PRE-BID ADDENDUM NO. # 2

PROJECT: Orange County Community College
Orange Hall Theater HVAC Unit Replacement
OCCC Project No. ITB-OCCC-2023-20
F.E. Project No. 22-230

DATE: November 3, 2022

SKETCH No:
SKHE-100.1

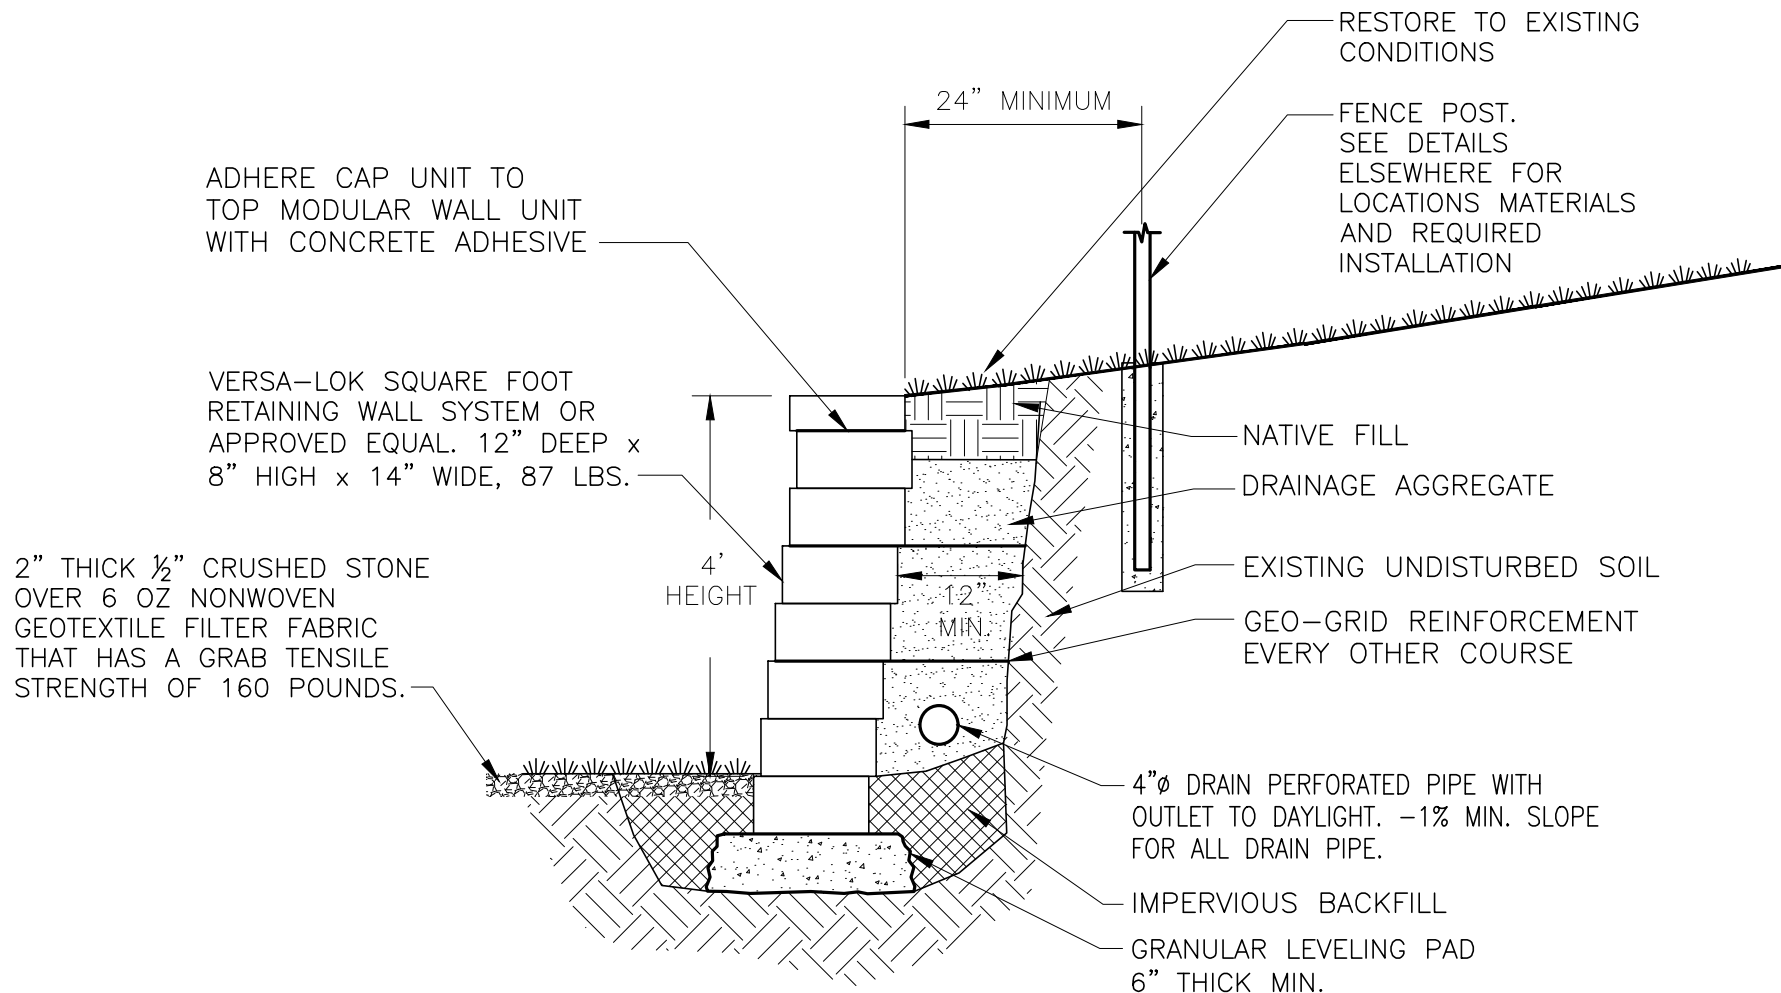
14. Please clarify options as stated on detail 5/HE-701 Modular Concrete Block Retaining Wall

FE Response: Please see attached sketches SKHE-100.1, SKHE-701.1, SKHE-701.2, SKHE-701.3, SKHE-701.4, SKHE-701.5 with clarifications

STEP WALL FROM
4' HIGH TO
1' HIGH
AS REQUIRED

4' HIGH
RETAINING WALL

PROVIDE NEW RETAINING WALL.
SEE DETAIL 5/HE-701
